(210) 308-9991
INDIAN HILLS UNITS 3 & 5
POADP
DRAWN BY: WTF
FILE: 971POADP
APPROVED BY: NF
SCALE: 1" = 50'
DATE: AUGUST 1999
SHEET 1 OF 1
REV. NO.
JOB NO. 97132 & 97133
P:\BILL\BURKE\97\POADP.DWG Wed Aug 11 18:04:47 1999 FISHER ENGINEERING, INC.

Re: Indian Hills POADP POADP # 644

The City Staff Development Review Committee has reviewed Indian Hills Preliminary Overall Area Development Plan # 644. Please find enclosed a signed copy for your files. Although your plan was accepted, please note the following:

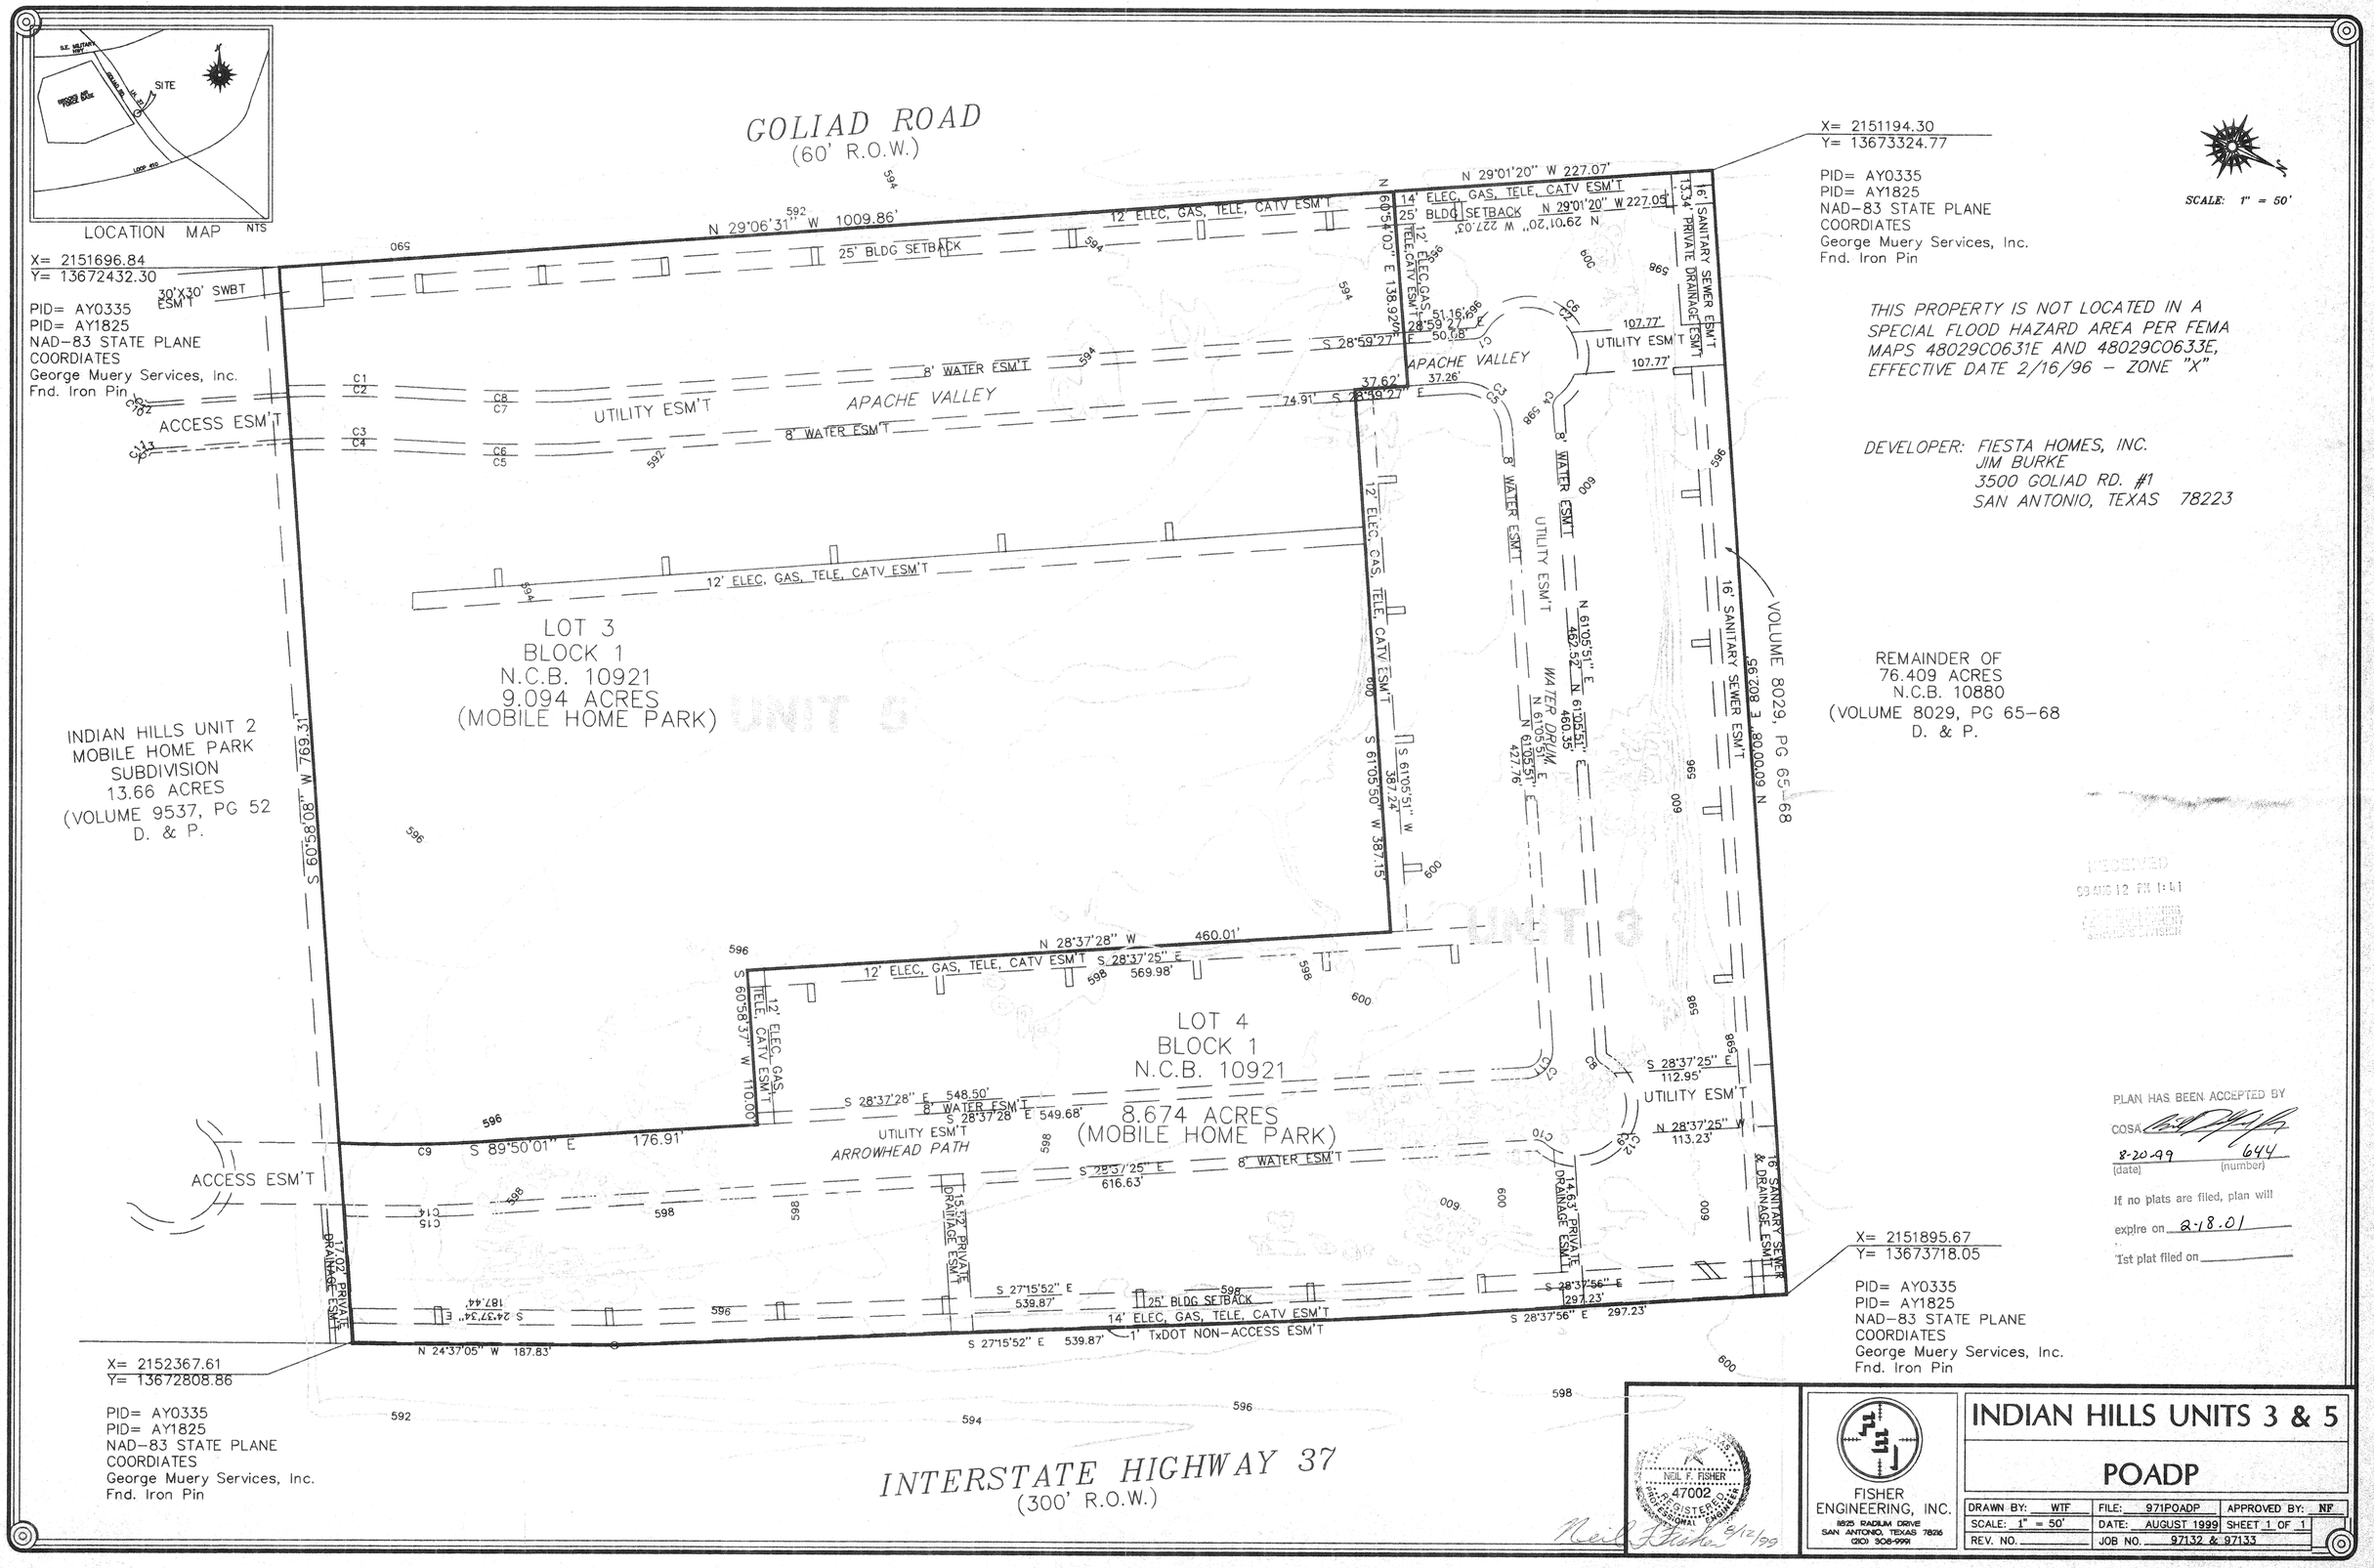
- Based on the topography, a Flood Plain Study and drainage review will probably be required during the platting process.
- In consideration of public safety and convenience, excessive grades by reason of topography should be avoided in street layouts and arrangements.

- Access and R.O.W. issues along State facilities will need to be resolved with the Texas Department of Transportation (TXDOT). For information about these requirements you can contact TXDOT at 615-5814.

- This development will need to comply with tree preservation ordinance #85262. For information about these requirements you can contact Building Inspections at 207-7102.

- It will be expected that you will plat all of the property depicted in your POADP, to include: floodpains, drainage areas and open space.
- I would encourage you to work closely with the school district, so that they can plan accordingly.

- A Mobile Home Park Plan will be required before any plats can be scheduled for approval by the Planning Commission.

- At the time of platting, the applicant must provide evidence of a irrevocable ingress/egress easement to Goliad Rd. utilizing the private drives in Indian Hills Unit 2 Subdivision to the south.
